**DOCUMENT 00 91 03  
ADDENDUM NO. 3**

PROJECT: 2024 Smith and Spillane MS Renovations  
BID DATE: **Thursday, February 20, 2025 (no Change)**  
FROM: Carolina Weitzman, A.I.A.  
Natex Corporation Architects  
447 Heights Blvd, Houston, TX 77007  
TO: **Prospective Bidders**

**MECHANICAL**  
**DEMOLITION FIRST**  
**FLOOR PLAN - AREA 'C'**  
**M0.03**

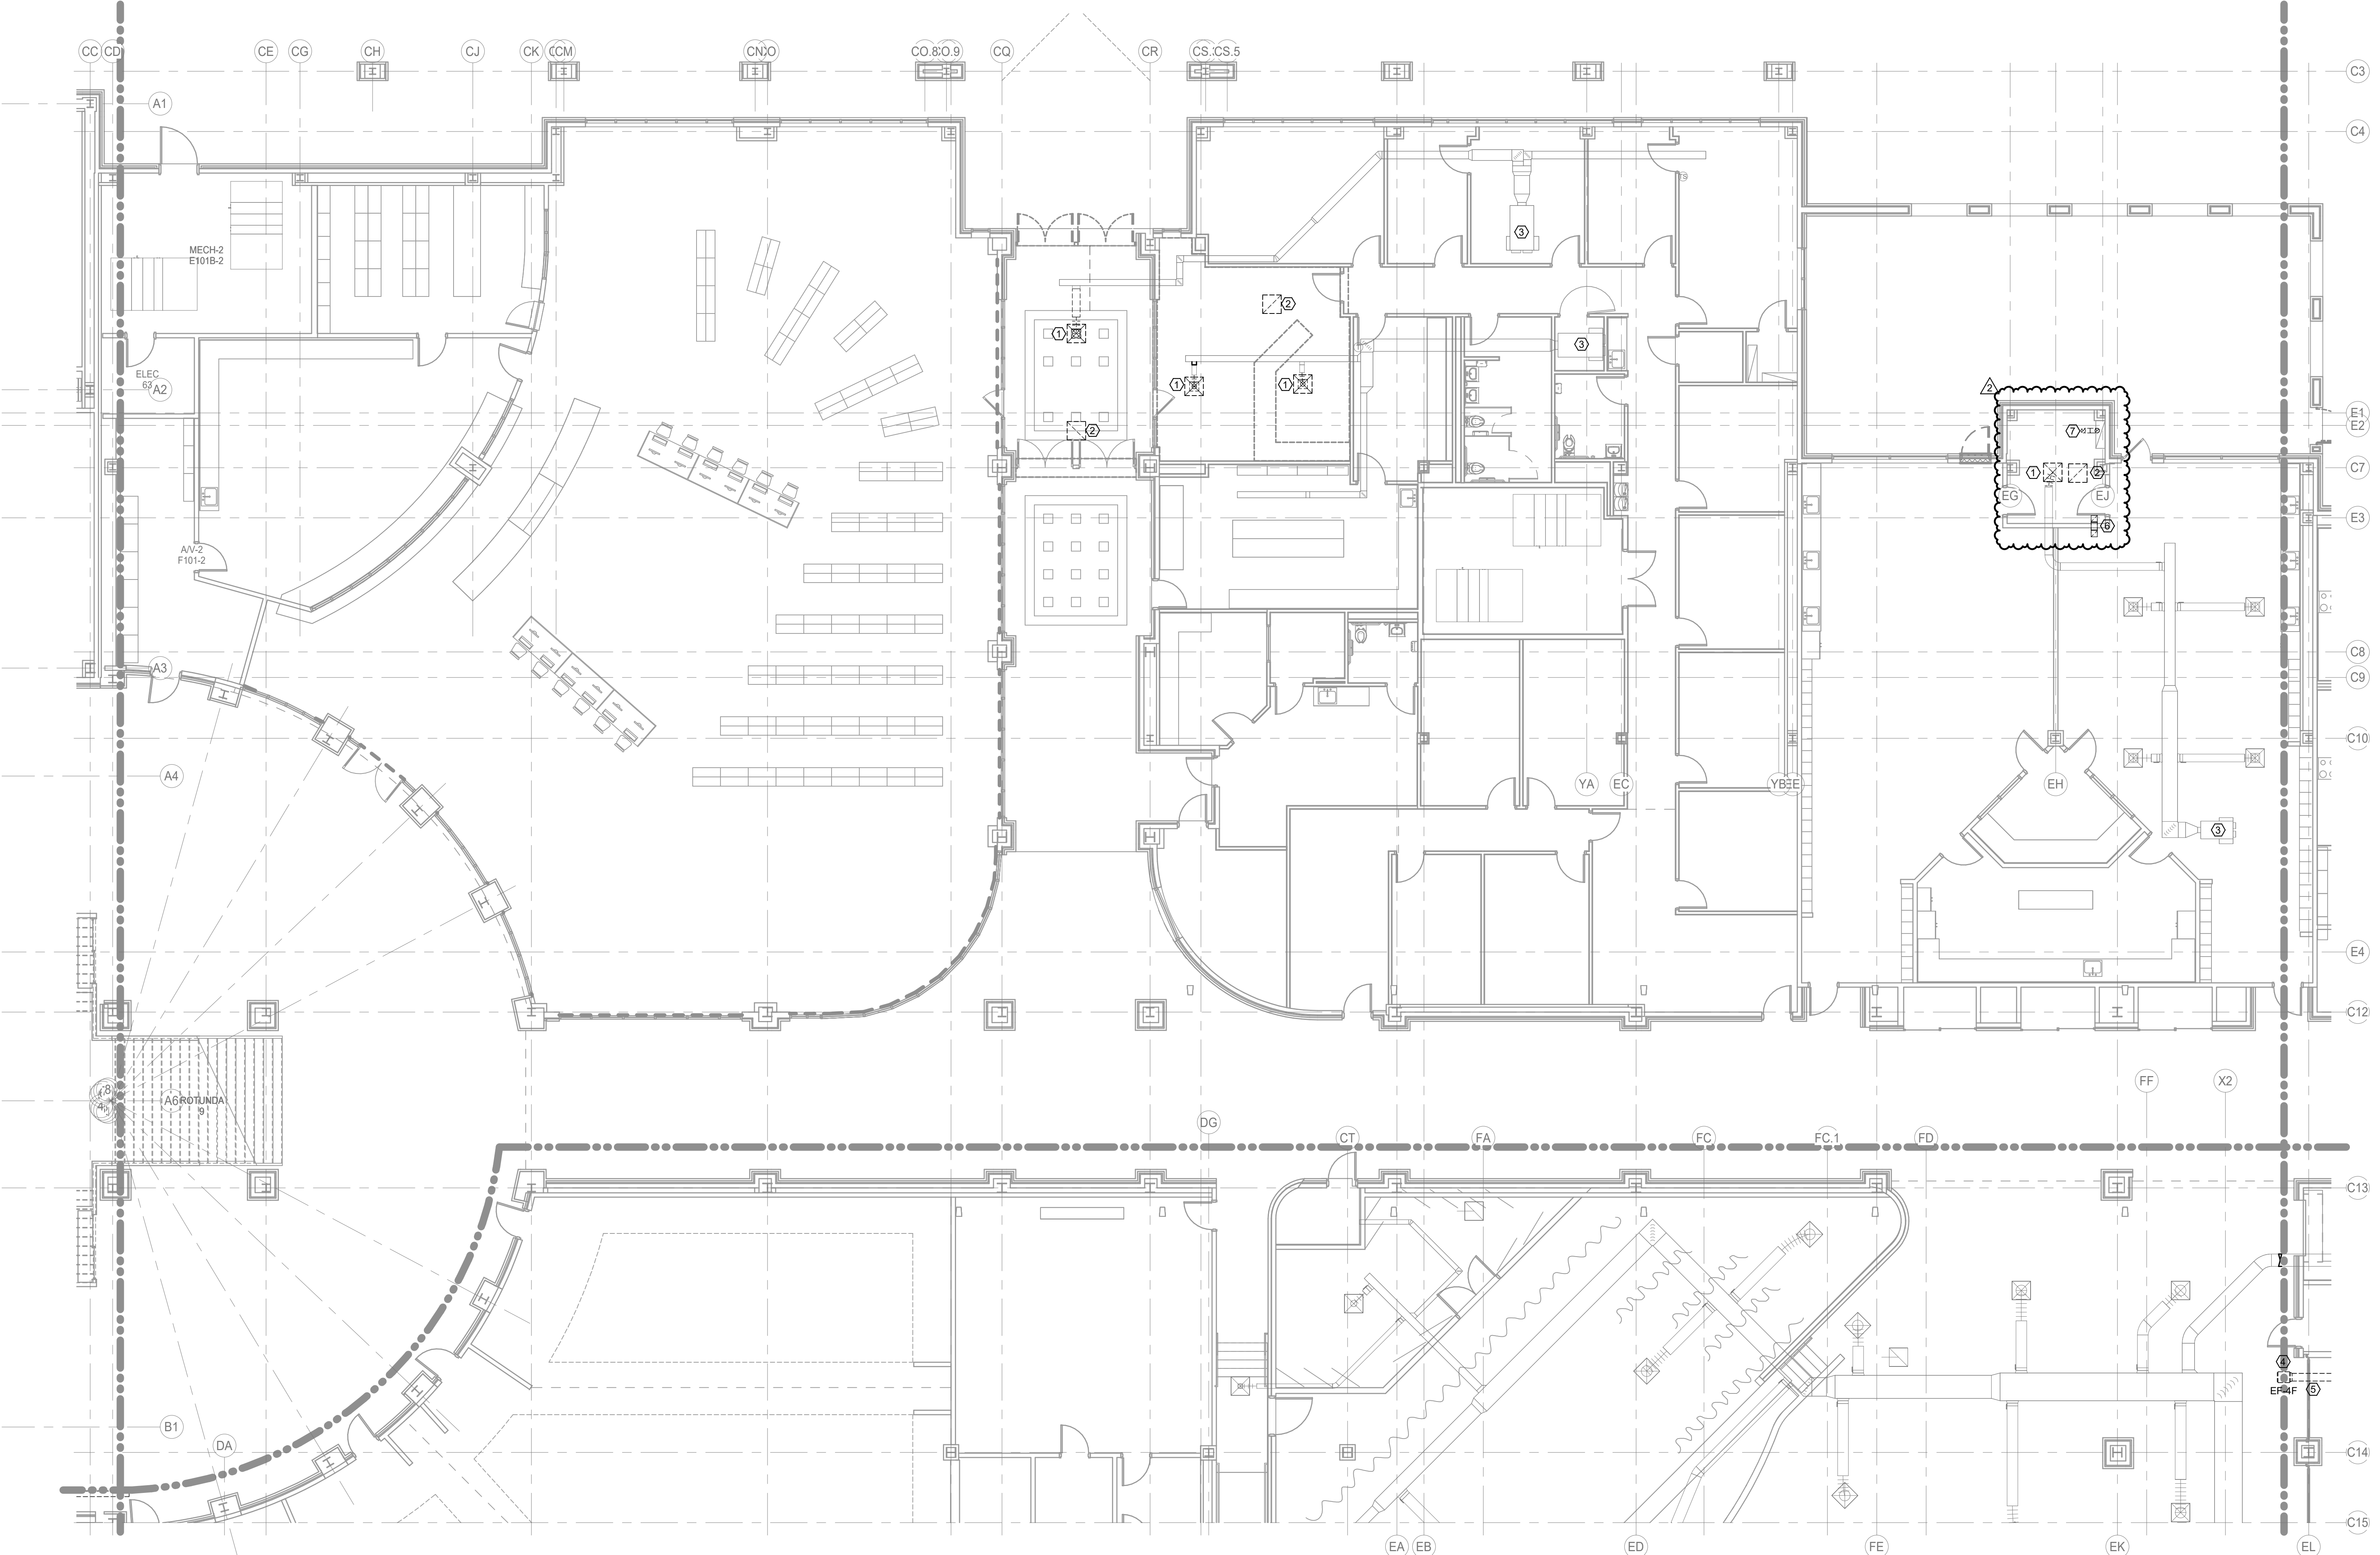
1. M0.03 MECHANICAL DEMOLITION FIRST FLOOR PLAN – AREA 'C'
  - a. Refer to revised plan for additional demolition in kiln room.
2. M0.04 MECHANICAL DEMOLITION FIRST FLOOR PLAN – AREA 'D'
  - a. Refer to revised plan for additional ductwork demolition.
3. M1.00 – MECHANICLA SITE PLAN
  - a. FIELD STORAGE – Relocated EF-SB-1.
4. M1.03 MECHANICAL FIRST FLOOR PLAN – AREA 'C'
  - a. Refer to revised plan for kiln room exhaust.

**16 KILN EXHAUST DETAIL**  
 SCALE: NONE

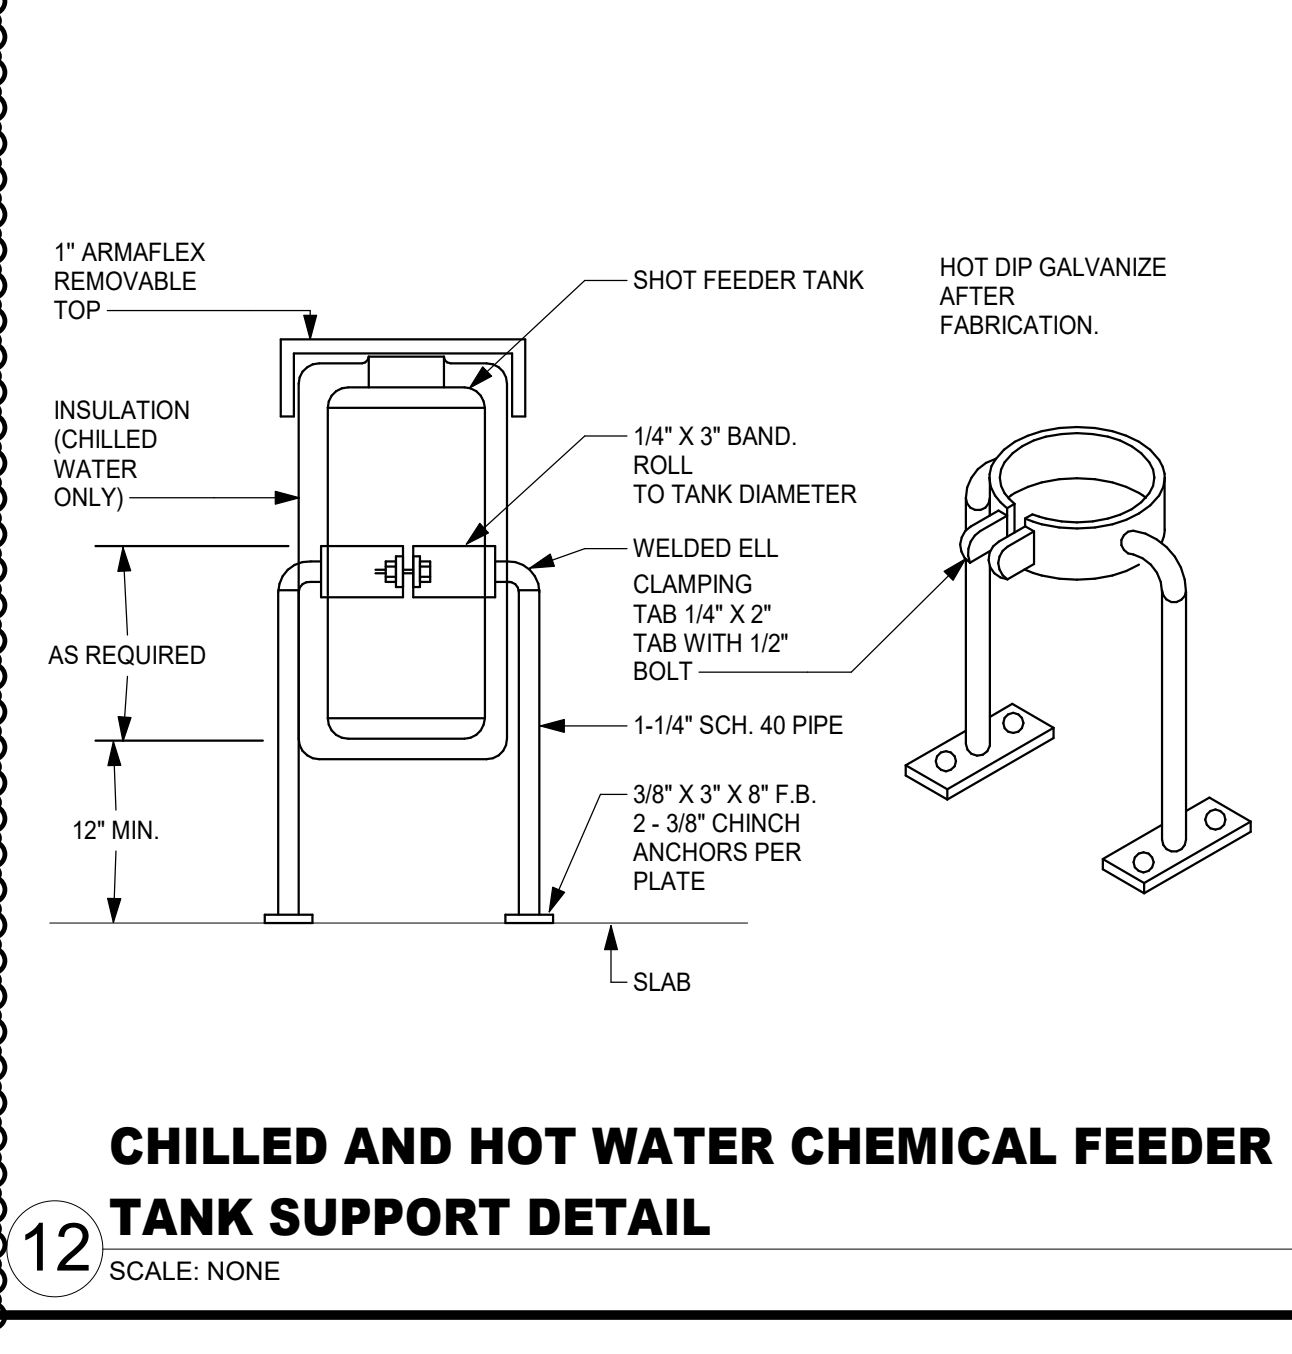
5. M1.04 MECHANICAL FIRST FLOOR PLAN – AREA 'D'
  - a. Refer to revised plan for revised ductwork.
6. M3.01 MECHANICAL DETAILS
  - a. Refer to revised plan for kiln exhaust detail.

Project Number: 23073  
 Date: 26 JANUARY 2025  
 Drawn By: WHL / KLO  
 MECHANICAL  
 CONTROLS FIRST  
 FLOOR PLAN - AREA A,  
 B, C, D  
**M5.01**

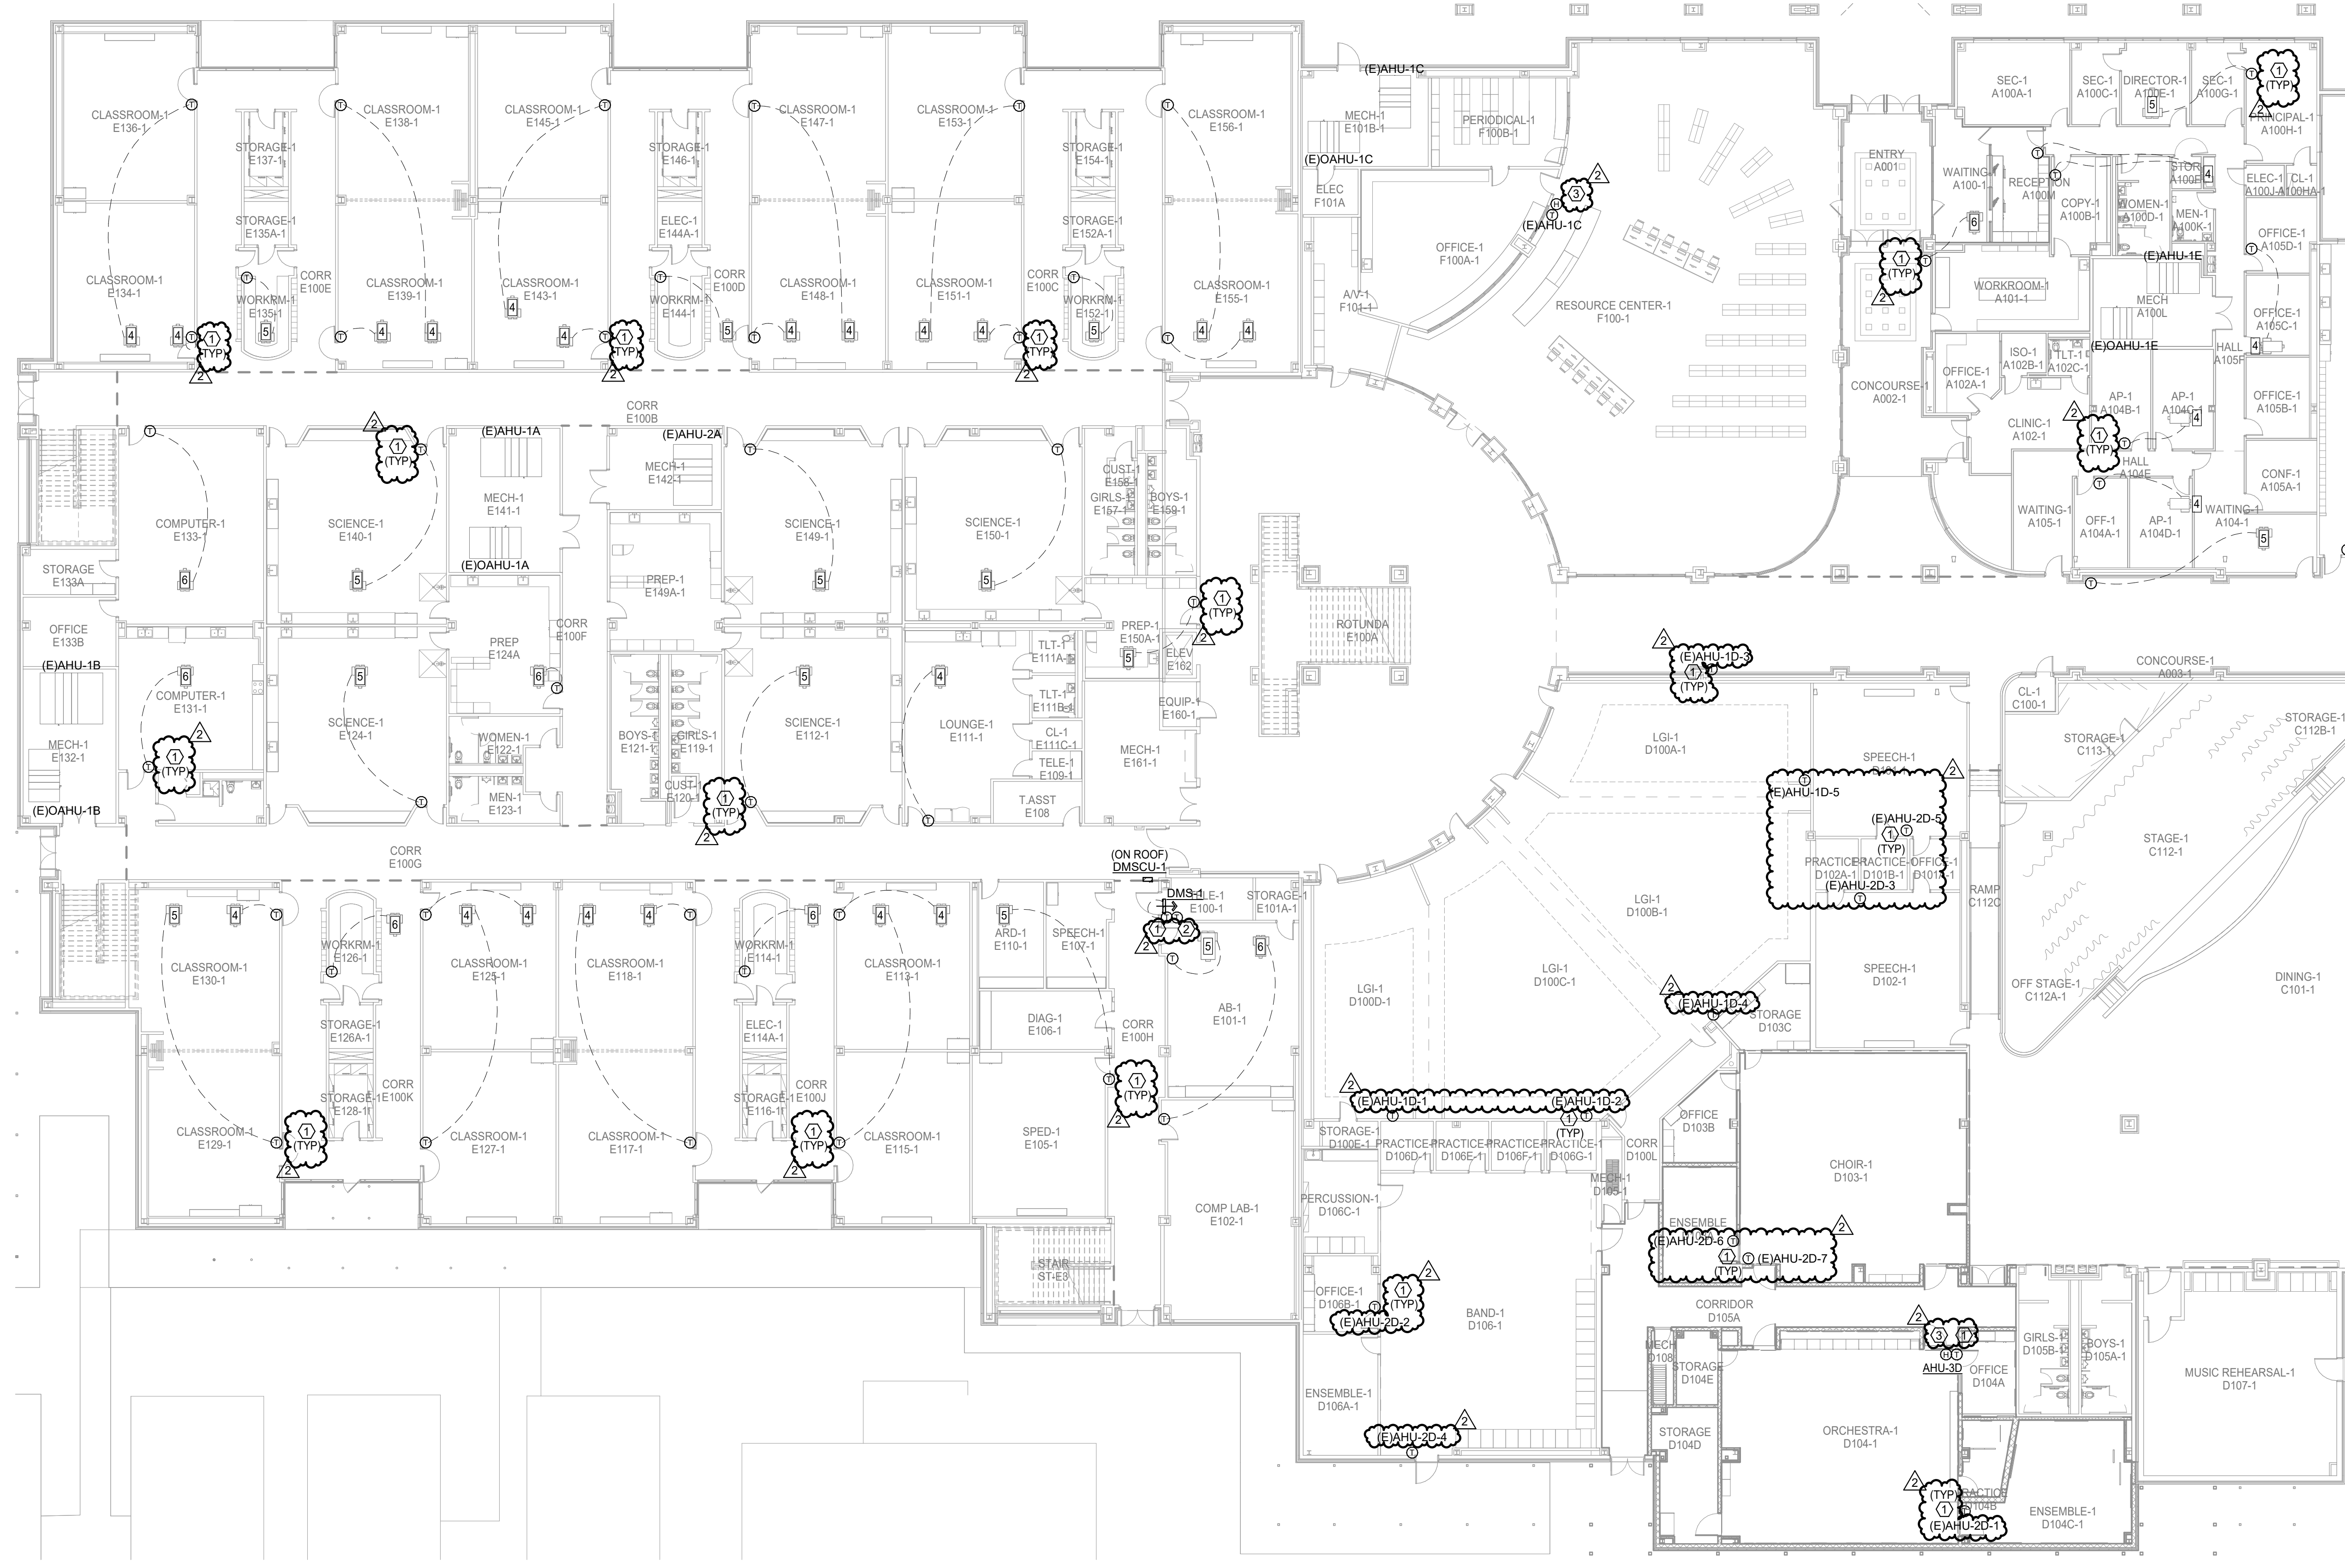
7. M4.01 MECHANICAL SCHEDULES
  - a. Refer to revised plan for schedule for EF-1.
8. M5.01 MECHANICAL CONTROLS FIRST FLOOR PLAN – AREA A,B,C,D
  - a. Refer to revised plan for additional controls scope.
